City of Sugar Hill Planning Staff Report TCO Design Review 21-002

SUBJECT: Town Center Overlay District (TCO) design review

Medical office, Sycamore Road at Nelson Brogdon Boulevard

L1.0

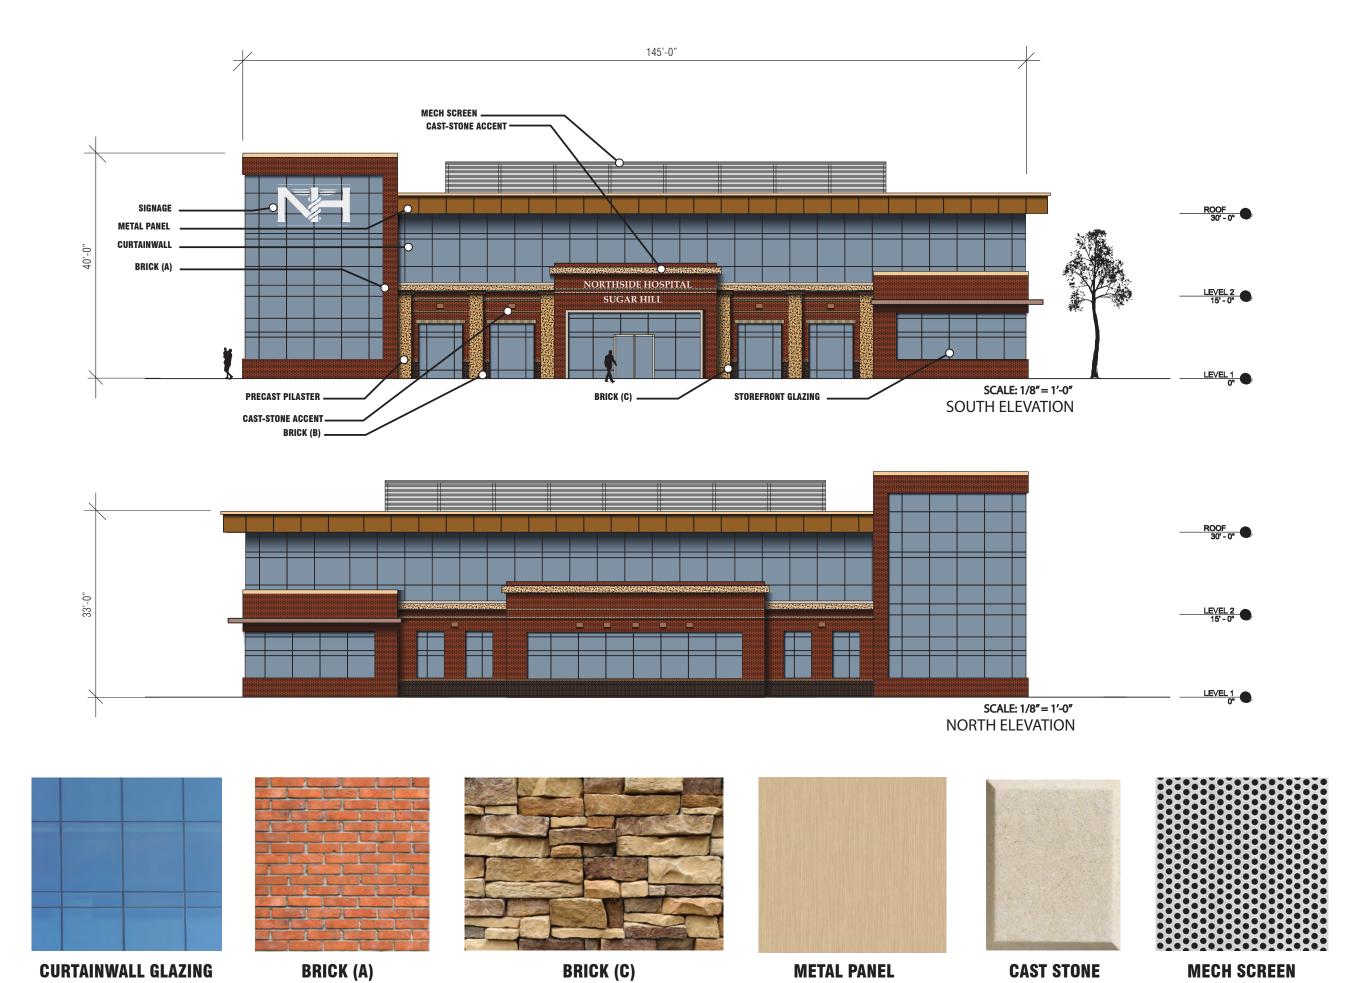
- 2. Sidewalk along GA Highway 20 shall include brick edging as approved in coordination with the City of Sugar Hill and Georgia Department of Transportation (GDOT). Sidewalk shall extend eastward to the matching sidewalk being constructed by the current developer of the Cadence mixed use project. Extend upgraded sidewalks and streetscape elements along Sycamore Road frontage (replace existing damaged sidewalk sections as necessary).

- 4. Developer shall provide ornamental streetlights as approved in coordination with City of Sugar Hill and GDOT along the entire length of the Highway 20 and Sycamore Road frontage.
